Euro Arte Apparels Ltd.

Plot - 346, Kabirpur, Ashulia, Savar
(24.009166N, 90.247896E)

28th November 2017

Ground Floor Slab Layout

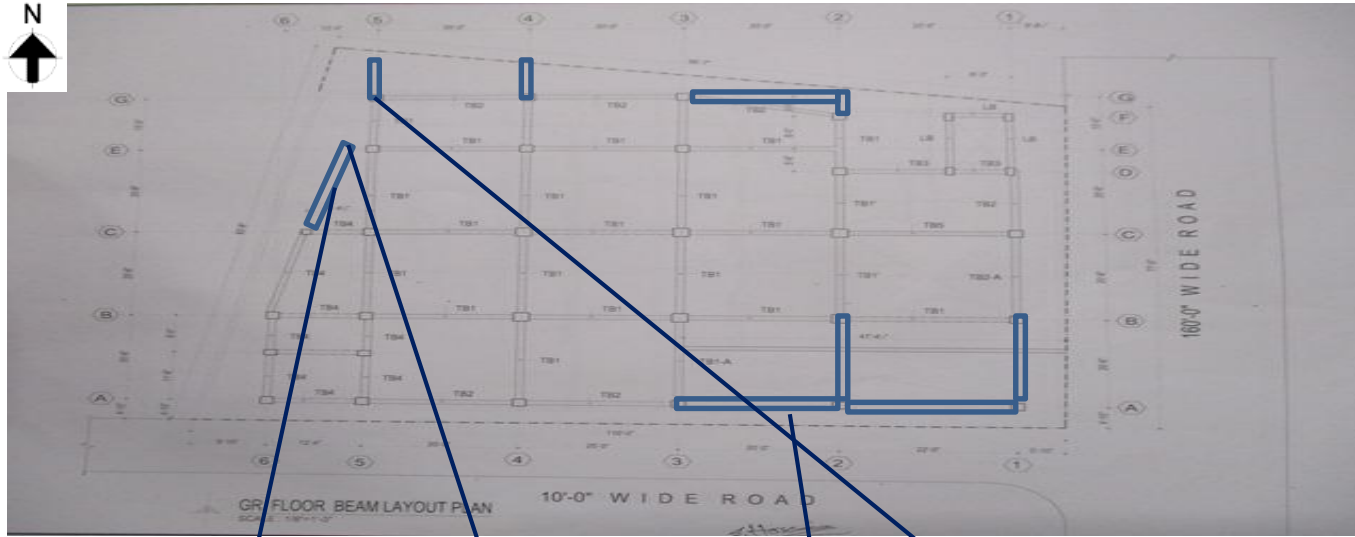
1850mm and 900mm wide cantilever on north side and 600mm wide cantilever on south side found which was not mentioned in drawing

Marked beams were found in every floor which were not mentioned in as built drawing. Factory is required to revise As – Built drawings reflecting the on site condition.

Provided Beam Layout

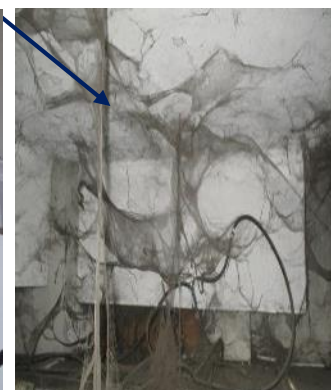
Beam Size measured 300mm (w) x 350mm (d/s)

Beam Size measured 300mm (w) x 400mm (d/s)

Beam Size measured 250mm (w) x 400mm (d/s)

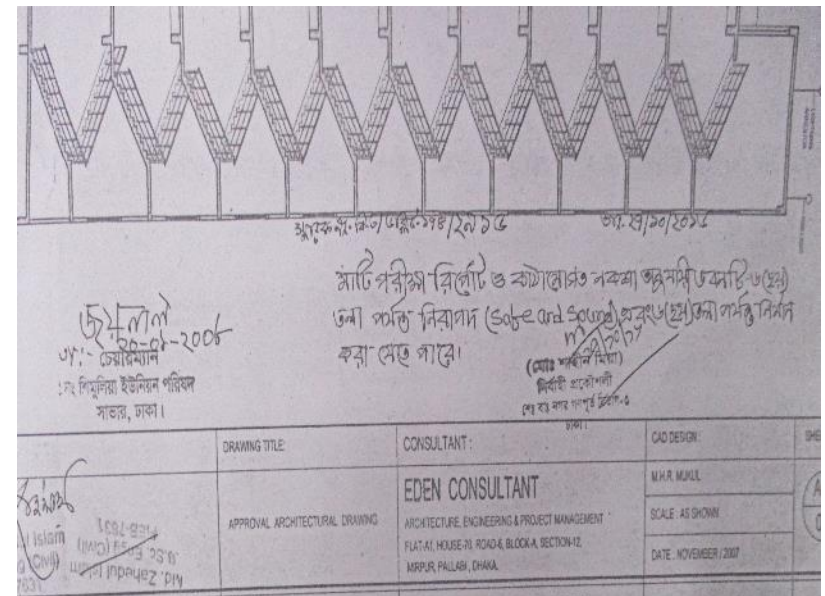
Advise to provide Isolated column footing of suitable dimension at 7'-6" depth from the existing ground level; the shallow foundations particularly for buildings upto 9-storied may be provided after improving the foundation base. This may be done in the following way:

The existing soil should be excavated to a depth of 7'-6" measured from the EGL. The excavated base should then be back filled with sand (F.M. around 2.5) through compaction preferably with 0'-6" at a time and up to a height of 7'-6" measured from the EGL. Addition of Brickbats during the process is expected to increase the degree of compaction in a more satisfactory way. The bearing capacity of the Isolated Column footing foundation over the improved base shall be considered net bearing capacity 5.00 to 5.50 KSF (F.S. = 3.0).
